SE Holgate : I-205 to 122nd – typical cross section

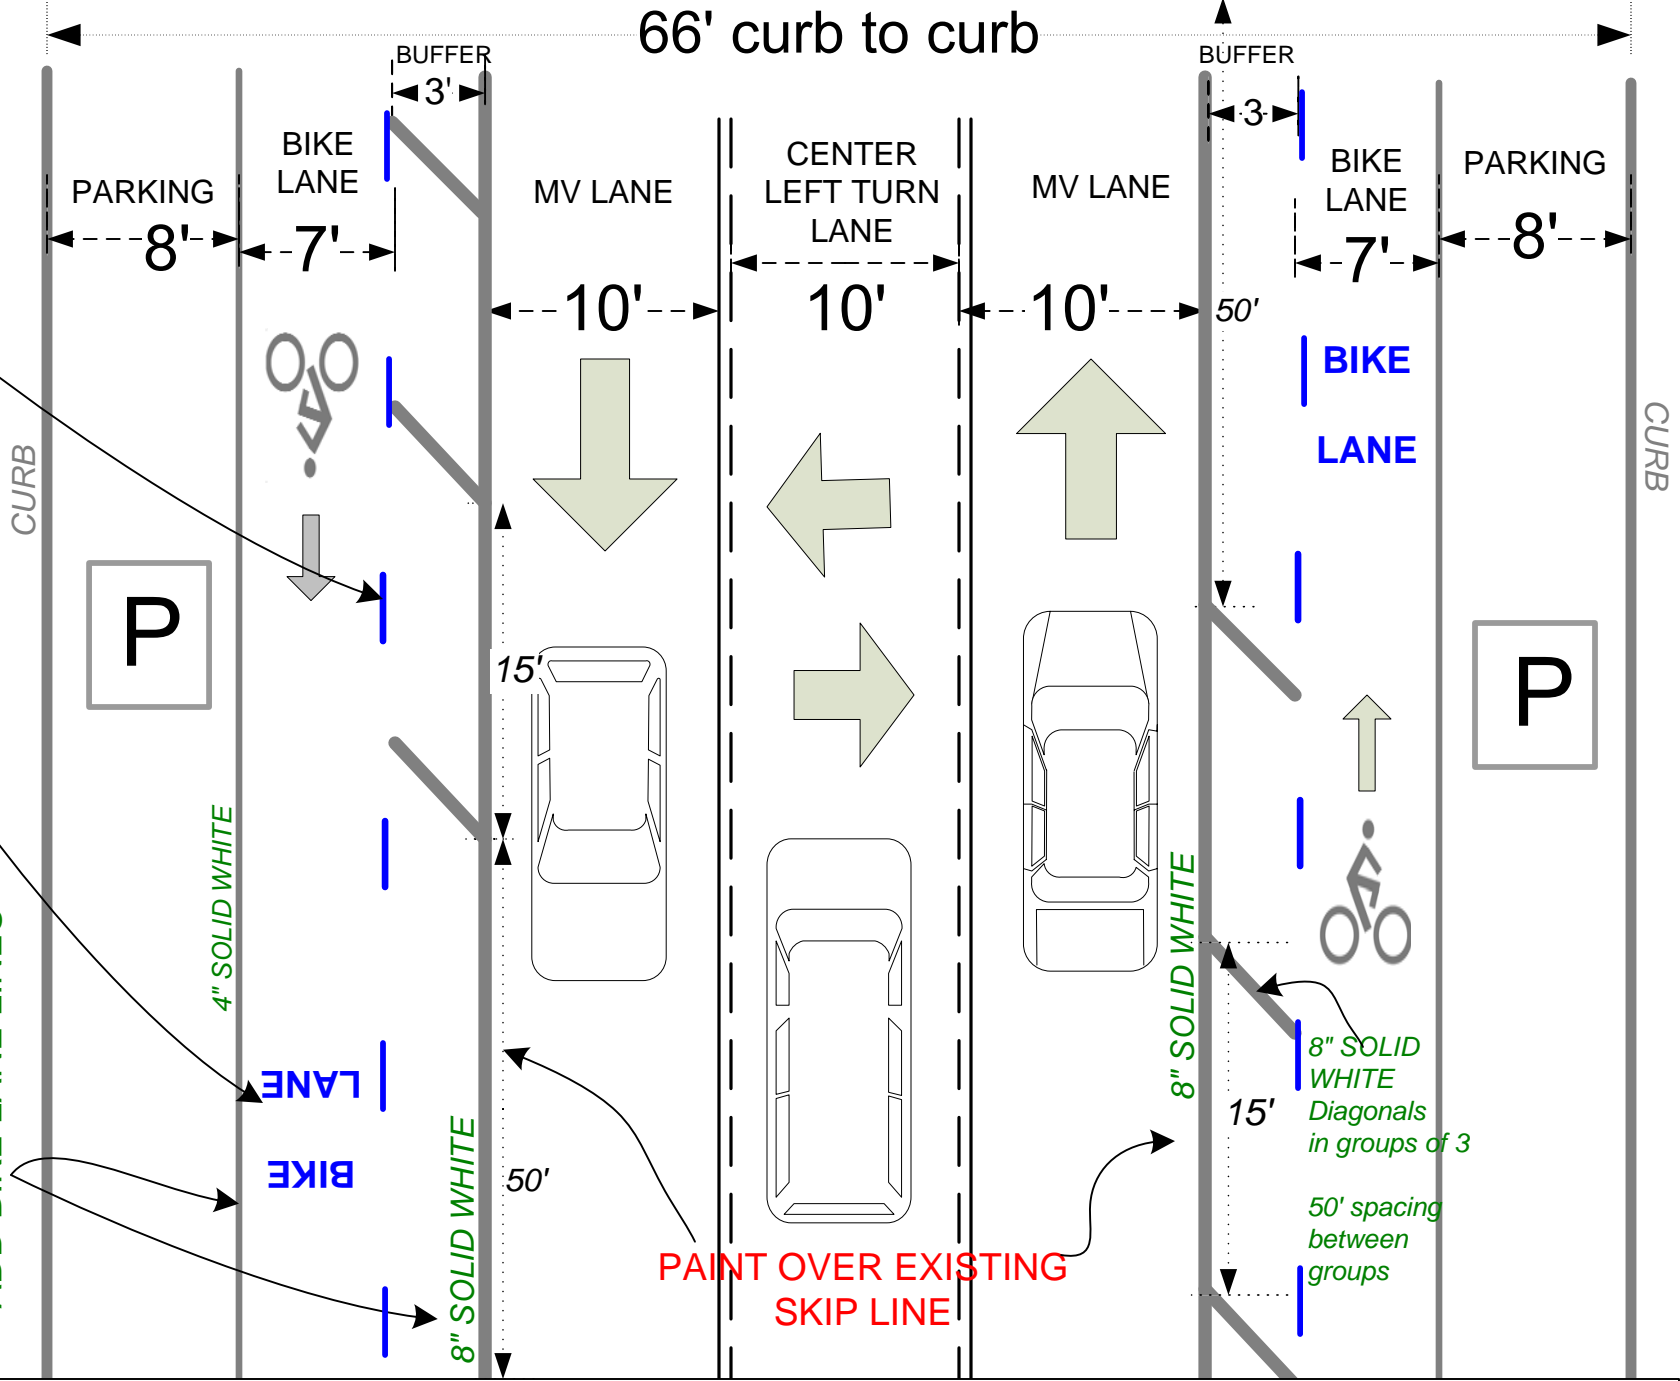
TO BE ADDED (in blue):

ADD "BIKE LANE" Pavement Marking
ADD 4" DASHED WHITE LINE between bike lane and buffer

ADD BIKE LANE LINES

8" SOLID WHITE

3 LANE CROSS SECTION – keep existing center lane lines
